SUBJECT : ImageQuest Co., Ltd.
FCC ID: PJJET1947L
Class II Permissive Change
Orig. Grant Date: December 18, 2003

Transmitted herewith, on behalf of ImageQuest Co., Ltd. is an application for a FCC Part 15 Subpart B Certification of the following 19-inch LCD Monitor :

FCC ID : PJJET1947L
Model : ET1947L-0NWA-1-N-TR

1. Attach a gasket on the Main Frame Cover

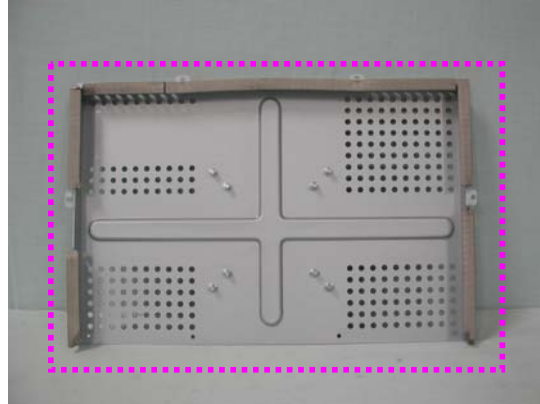
2. Attach a gasket between Main Frame and LCD panel
